Item ID: D212-664-201

Item Name: Crosstube Aft

DART AEROSPACE LTD		Work Order:	99868
Description: Crosstube High Aft (205/212)		Part Number:	D212-664-201
Inspection Dwg: D212-664-241 Rev: D		Page 1 of 1

DRAWING NO. D212-664-241	TITLE CROSSTUBE ASSY (205/212 HI AFT)	REV. D	DART AEROSPACE LTD ENGINEERING ORDER		D.E.O. NO. D212-664-241-D-1	SHEET NO. SHEET 1 OF 2	SCALE NTS
DRAWN	CHECKED	MFG. APPR.	APPROVED	DE APPR.			
DATE 11.04.07	DATE 11.04.11	DATE 11.04.12	DATE 11/04/12	DATE 11.04.12

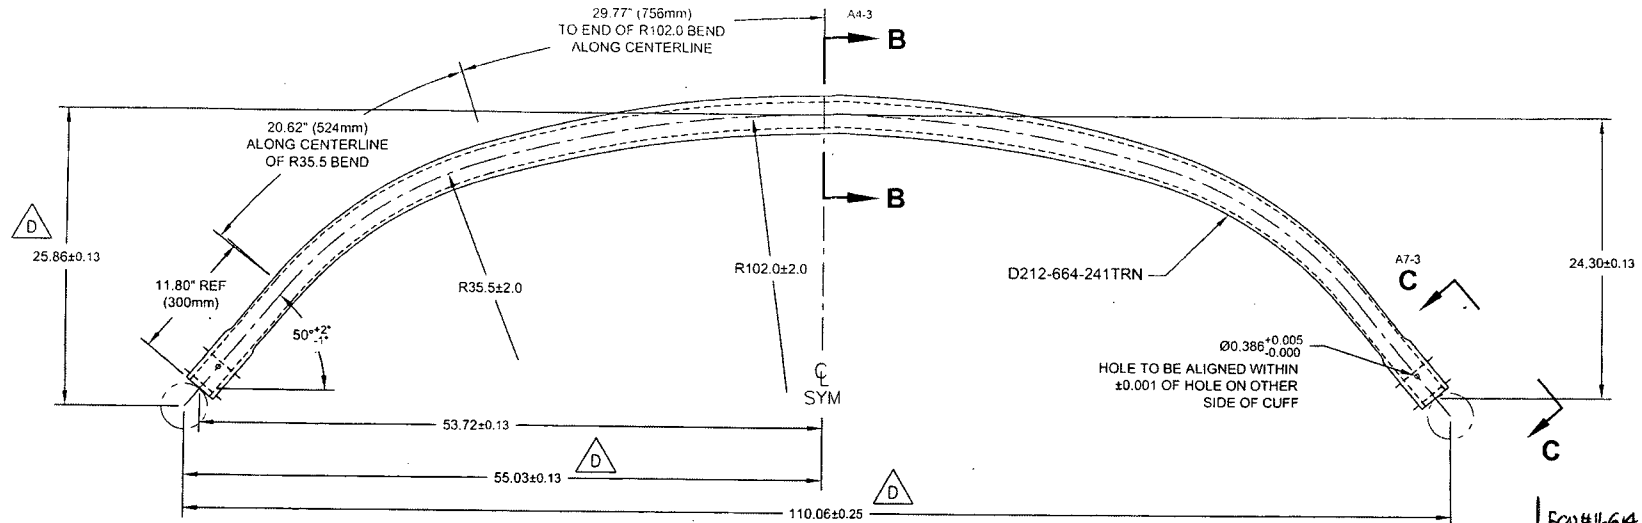
REPLACE MAGNOBOND WITH PROSEAL.

NOTE 12 & 15, SHEET 1 IS AMENDED AS FOLLOWS:

- 12) TO INSTALL D2940-1 SUPPORT: ABRABE MATING SURFACE OF SUPPORT AND CROSSTUBE WITH 180-GRIT SANDPAPER AND REMOVE RESIDUE WITH MEK (OR EQUIVALENT). APPLY A 0.04" TO 0.07" THICK LAYER OF PROSEAL 890 CLASS B-2 (OR AMS-S-8802 CLASS B-2) SEALANT TO MATING SURFACE OF SUPPORT.
- 15) TORQUE CLAMPS 80 TO 100 IN-LB. ENSURE AT LEAST 1.5 THREADS SHOWING IN SAFETY AND THAT NUT HAS NOT BOTTOMED-OUT AFTER TORQUING. **PRIOR TO PACKAGING, RE-CHECK TORQUE ON CLAMPS AFTER PROSEAL 890 SEALANT HAS CURED FOR 72 HOURS.**

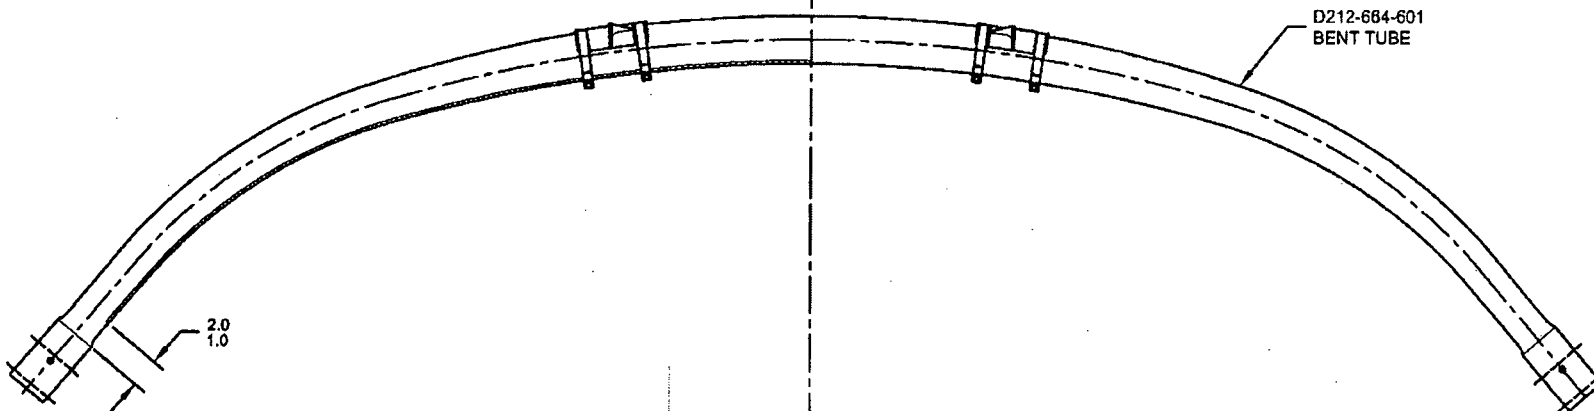
ADD AN INSPECTION WINDOW TO UNDERSIDE OF CROSSTUBE.

NOTES 2 OF SHEET 1 IS AMENDED AS FOLLOWS:

- 2) FINISH: CHEMICAL CONVERSION COAT PER DART QSI 005 4.1  
 PRIME INSIDE AND OUTSIDE PER DART QSI 005 4.2  
 MASK UNDERSIDE OF CROSSTUBE AS SHOWN (HATCHED AREA) AND  
 PAINT OUTSIDE PER DART QSI 005 4.2  
 REMOVE MASKING AND APPLY CLEAR COAT

**FIGURE 1: SUPPORT INSTALLATION**

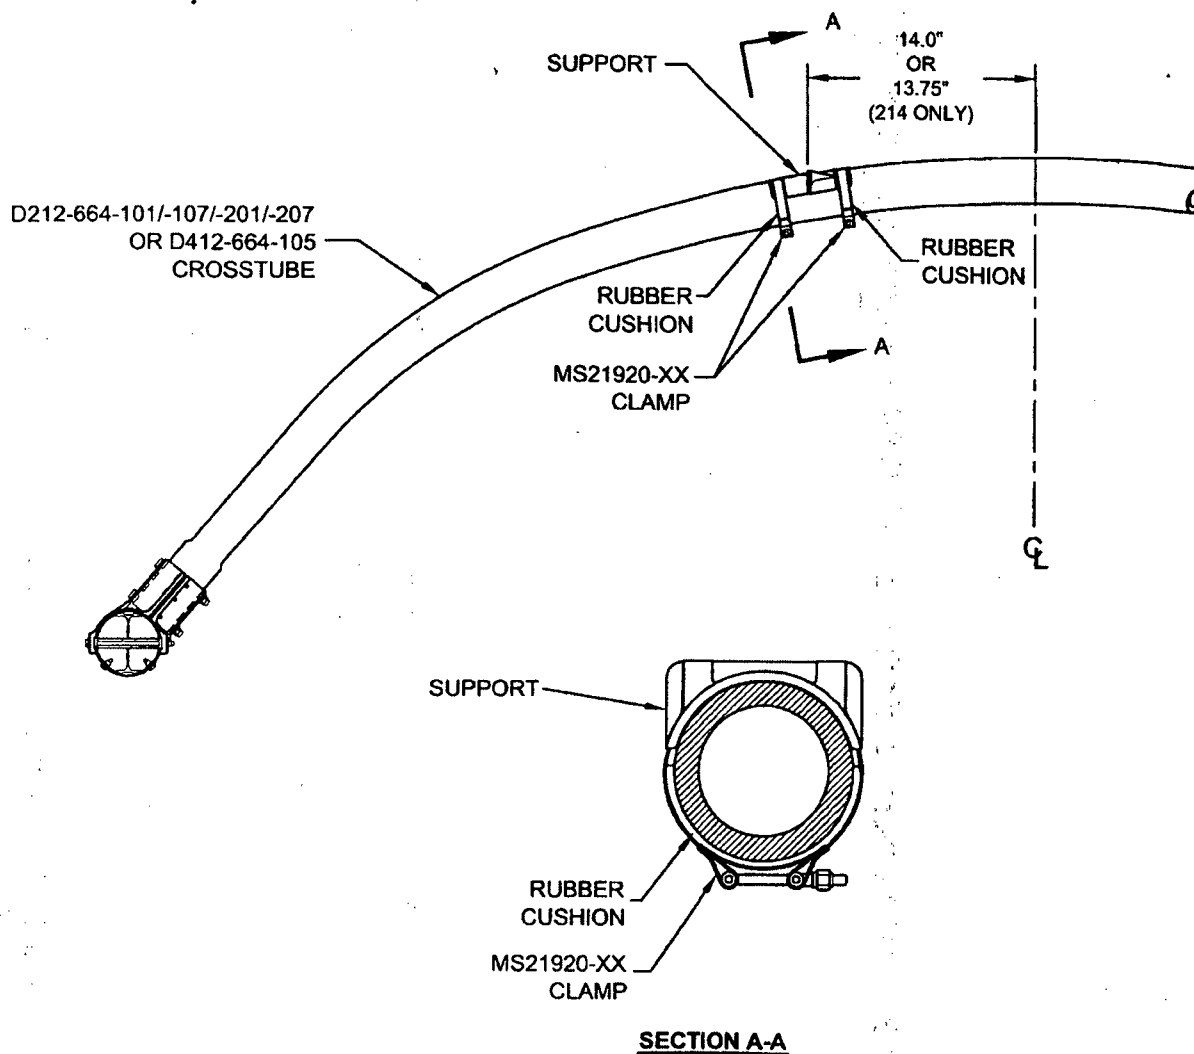
For the crosstubes listed above, section 32.4 of ICA-D212-664 is amended as follows. Use Figure 1 of this service instruction and Figures 32-2 to 32-9 of ICA-D212-664 for further reference. For crosstubes of an earlier change number, it is recommended that if the supports are removed, the supports should be reinstalled using the procedure listed below.

- 32.4.1 Locate the area on the crosstube for installation of support (see Figure 1 of this service instruction). For D212-664-101/-107/-201/-207 and D412-664-105 crosstubes, the outward face of the support tabs should be 14.0" (355mm) from the crosstube center for 204/205/210/412/UH-1 aircraft. For installation on 214B/B-1 aircraft, the outward face of the support tabs should be 13.75" (349mm). Ensure paint finish of crosstube is intact; touch up as required per Chapter 5 (5.3.9) of ICA-D212-664.

- 32.4.2 If present, remove any paint/primer on bottom of supports. Abrade mating surfaces of support and crosstube with 400-grit sandpaper. Saturate a clean cloth with MEK or 4105S Wash'n'Wipe Degreaser or equivalent and wipe until there is no residue.

- 32.4.5 Apply a 0.04" to 0.07" thick layer of Proseal 890 Class B or AMS-S-8802 Class B sealant underneath applicable support and install support as shown in Figure 1 of this service instruction.

- 32.4.6 Install the clamps opposite to crosstube support as shown in section A-A of Figure 1. Install rubber cushions underneath each clamp around the bottom circumference of the crosstube up to the crosstube centerline. Torque clamps 80-100 in·lb (9.0-11.3 Nm). It is acceptable to use smaller or larger sized MS21920-XX clamps than those listed in ICA-D212-664, ensure that after torquing the clamps per this instruction, the nuts are in safety but not bottomed out
